## Technical Service Bulletin

GROUP <b>BODY ELECTRICAL</b>	NUMBER <b>25-BE-005H</b>
DATE <b>MARCH 2025</b>	MODEL(S) <b>SEE BELOW</b>

**SUBJECT:** HORN ASSEMBLY REPLACEMENT  
(WARRANTY EXTENSION Z03)

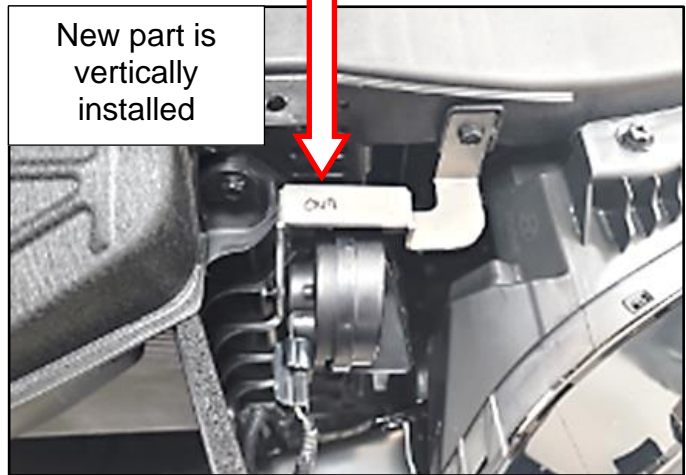
3. Replace both horns (high and low) in a vertical orientation by connecting the horn connectors to the external wirings.

Ensure the horns (high and low) are installed vertically with the bell holes facing downward to prevent water intrusion.

Old part is horizontally installed

New part is vertically installed

Part Number	Remarks
96611-AA900QQH 96621-AA900QQH	Extension wiring included
96611-AA700QQH 96621-AA700QQH	<b>NO</b> extension wiring
